CONTINENTAL MOTORS® AIRCRAFT ENGINE
CRITICAL SERVICE BULLETIN

CATEGORY 2
CSB15-7

SUBJECT: TSIO-550-K Oil Cooler Cross Fitting Replacement

PURPOSE: To replace oil cooler cross fitting (part number AN918-1J) with a new enhanced cross fitting (P/N 658607).

Figure 1. Cross Fitting Stack-Up, Prior Configuration

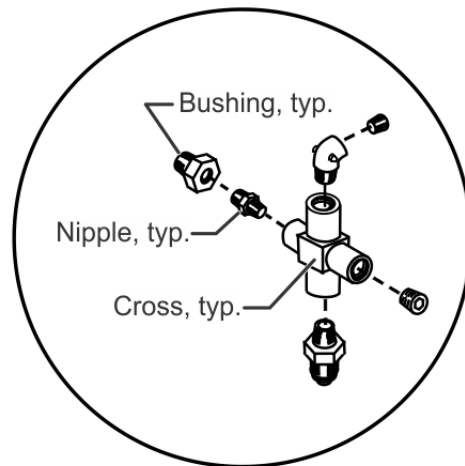
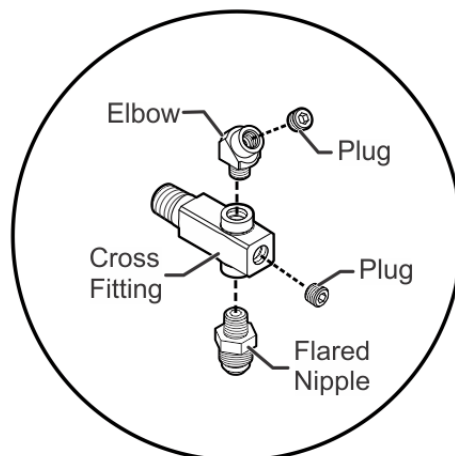
Continental Motors, Inc. (CMI) is aware of some occurrences in which there was a loss of engine oil due to a fractured nipple fitting that connects the cross fitting to the pipe bushing at the oil cooler. Design improvements consolidate the oil cooler cross fitting stack-up into a single part, which significantly increases the strength and provides a simplified installation procedure for installing the oil cooler cross fitting found on specified TSIO-550-K engines.

1. Eliminate the pipe bushing and nipple fitting stack-up (see Figure 1) typically found between the cross fitting and the oil cooler and replaces them with a single cross fitting (P/N 658607).
2. Provide a larger tool surface area on the cross fitting for support wrenches during subsequent fitting and b-nut installation.
3. Add a new requirement for engine model TSIO550-K to use the AN915-1J 45-degree elbow fitting to install the oil pressure sensor.

REMOVE AND REPLACE the superseded parts with new cross fitting (P/N 658607) using the same procedures located in your M-18 Maintenance and Overhaul Manual. Reference the latest revision of the CMI Illustrated Parts Catalog (IPC) to determine applicable additional connectors, elbows, or plug part numbers and adjust the instructions accordingly.

Figure 4. Hose and Tube Installation Support

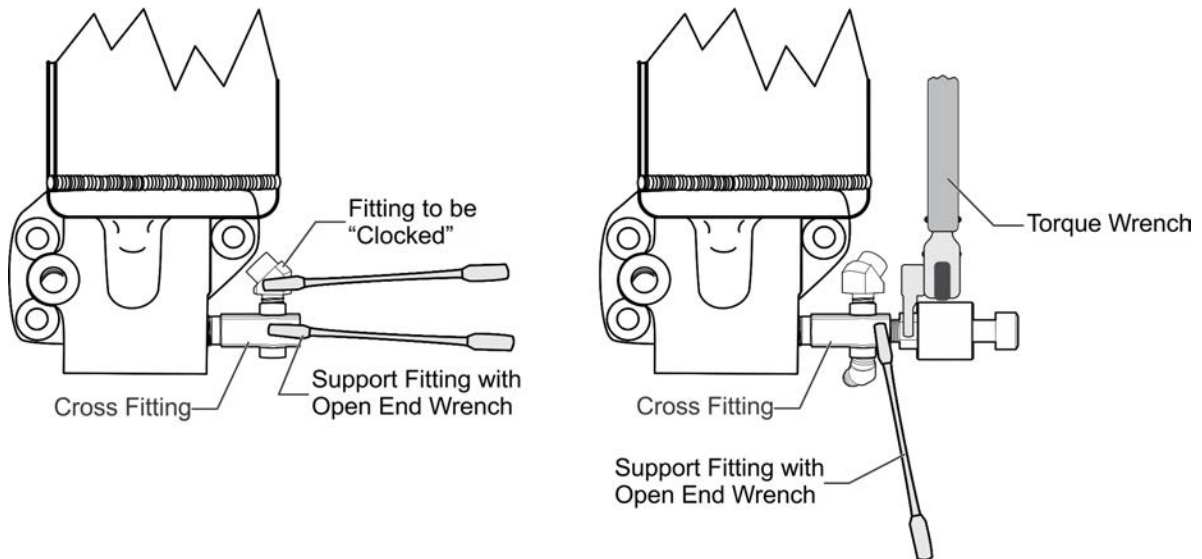
- b. Support the last fitting in the assembly on components that contain multiple fittings coupled in one location (see Figure 4). DO NOT over-torque fittings.

Figure 1. Cross Fitting Stack-Up, Prior Configuration

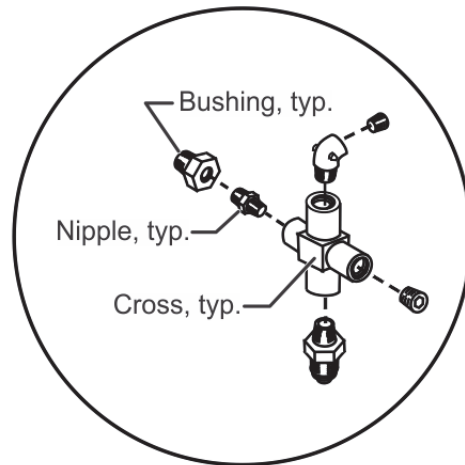
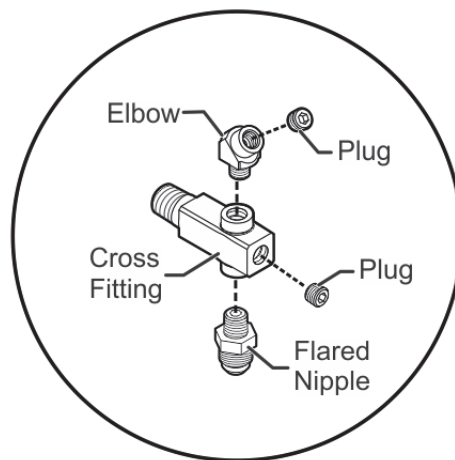
Continental Motors, Inc. (CMI) published CSB15-2 upon discovering isolated occurrences in which there was a loss of engine oil due to a fractured nipple fitting between the cross fitting and the pipe bushing at the oil cooler. Design improvements consolidate the oil cooler cross fitting stack-up into a single part, significantly increasing the strength and providing a simplified procedure for installing the oil cooler cross fitting found on specified TSIO550 engines. *If CSB15-2 was previously complied with on the TSIO550-K engine, no further action is required. Modifications described herein on engine serial numbers 1012296 and higher were accomplished at the factory.*

1. Eliminate the pipe bushing and nipple fitting stack-up (see Figure 1) typically found between the cross fitting and the oil cooler and replaces them with a single cross fitting (P/N 658607).
2. Provide a larger tool surface area on the cross fitting for support wrenches during subsequent fitting and B-nut installation.

REMOVE AND REPLACE the superseded parts with new cross fitting (P/N 658607) using the same procedures located in your M-18 Maintenance and Overhaul Manual. Reference the latest revision of the CMI Illustrated Parts Catalog (IPC) to determine applicable additional connectors, elbows, or plug part numbers and adjust the instructions accordingly.

Figure 4. Hose and Tube Installation Support

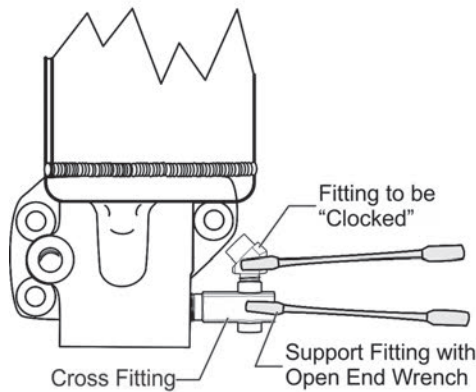
- b. Support the last fitting in the assembly on components that contain multiple fittings coupled in one location (see Figure 4). DO NOT over-torque fittings.

Figure 1. Cross Fitting Stack-Up, Prior Configuration

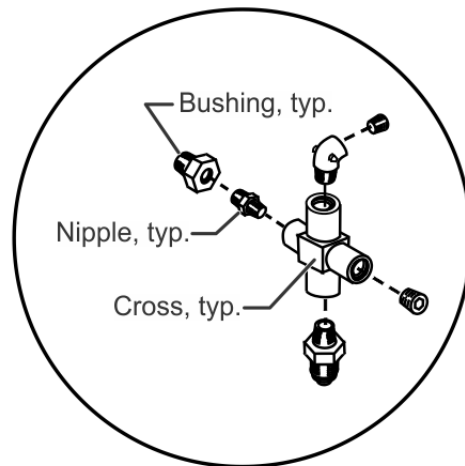
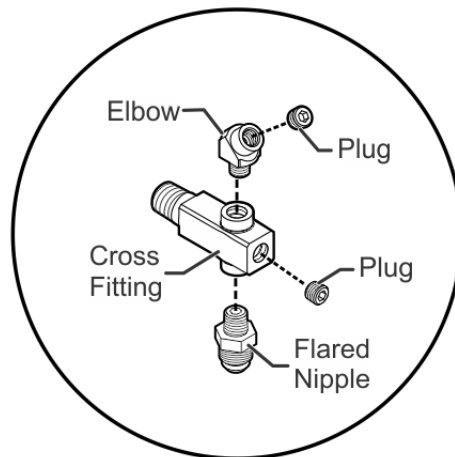
Continental Motors (CM) published CSB15-2 upon discovering isolated occurrences in which there was a loss of engine oil due to a fractured nipple fitting between the cross fitting (P/N AN918-1J) and the pipe bushing at the oil cooler. Design improvements consolidate the oil cooler cross fitting stack-up into a single part, significantly increasing the strength and providing a simplified procedure for installing the oil cooler cross fitting found on specified TSIO550 engines. *If compliance was previously achieved through CSB15-2 on the TSIO550-K engine, no further action is required. Modifications described herein on engine serial numbers 1012296 and higher were accomplished at the factory.*

- Eliminate the pipe bushing and nipple fitting stack-up (see Figure 1) typically found between the cross fitting and the oil cooler and replaces them with a single cross fitting (P/N 658607).
- Provide a larger tool surface area on the cross fitting for support wrenches during subsequent fitting and B-nut installation.

REMOVE AND REPLACE the superseded parts with new cross fitting (P/N 658607) using the same procedures located in your M-18 Maintenance and Overhaul Manual. Reference the latest revision of the CM Illustrated Parts Catalog (IPC) to determine applicable additional connectors, elbows, or plug part numbers and adjust the instructions accordingly.

Figure 4. Hose and Tube Installation Support

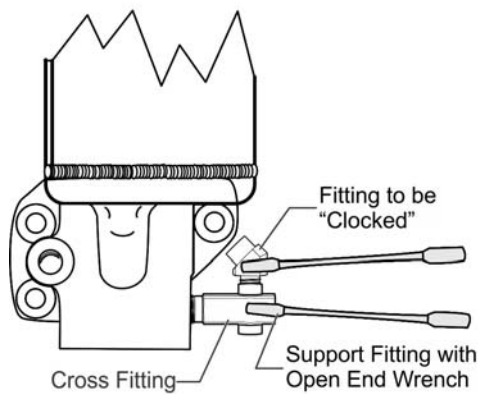
- b. Support the last fitting in the assembly on components that contain multiple fittings coupled in one location (see Figure 4). DO NOT over-torque fittings.
